PHAP15-00007

Date:	March 6, 2015 (Postponed from February 23, 2015)
Application Type:	Certificate of Appropriateness
Property Owner:	The Venice Group
Representative:	Carlos Silveyra
Legal Description:	Being Fr. 7 Alexander 9 & 10, City of El Paso, City of El Paso, El Paso County, Texas
Historic District:	Sunset Heights
Location:	1319 N. El Paso Street
Representative District:	#8
Existing Zoning:	A-3/H (Apartment/Historic)
Year Built:	1930
Historic Status:	Non-Contributing
Request:	Certificate of Appropriateness for the removal and replacement of doors and windows and the installation of through-wall grilles after-the-fact
Application Filed:	2/9/2015
45 Day Expiration:	3/26/2015

ITEM #1

Certificate of Appropriateness for the removal and replacement of doors and windows and the installation of through-wall grilles after-the-fact

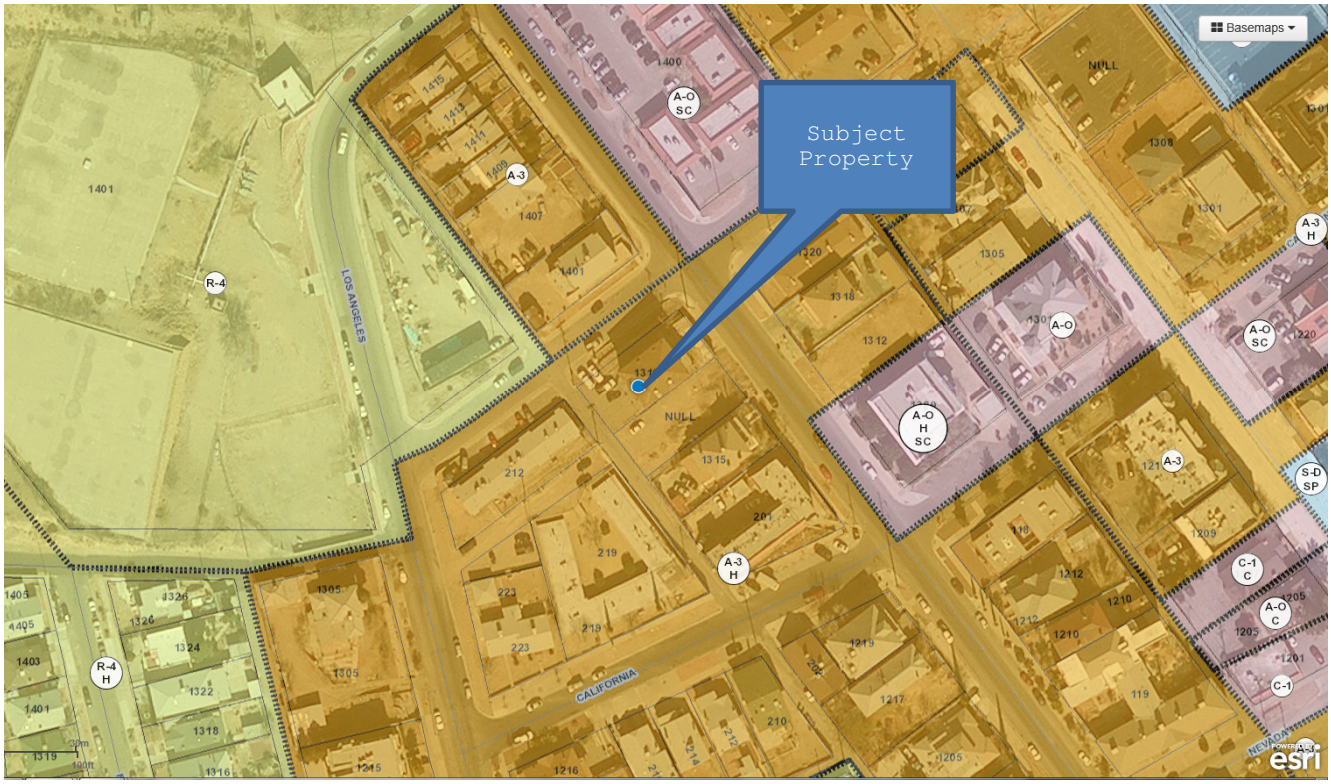
The Historic Preservation Office recommends DENIAL of the proposed scope of work based on the following recommendations:
